Planning Act 2008:**Additional Written Representation of Alcemi Storage Developments 1 Limited (“Alcemi”)****Application by National Grid Electricity Transmission Limited (“NGET”) for an Order granting Development Consent (“DCO”) for the Norwich to Tilbury (“N2T”) Scheme**

Planning Inspectorate Reference: EN020027

**Section 56 Planning Act 2008:
Relevant Representation of Alcemi Storage Developments 1 Limited (“Alcemi”)**

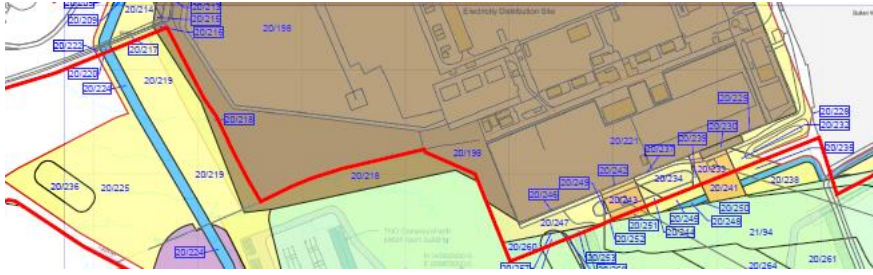
There is one plot, 20/218, where permanent acquisition is proposed which overlaps with the Alcemi Option land. This is shown on the plan excerpt below, where the entirety of plot 20/218 appears to sit within the Alcemi Option land red line:

Alcemi are looking to understand what is proposed for this area and how it may affect their project. Could a lesser right perhaps be acquired here, so as not to interfere with the Alcemi Option land?
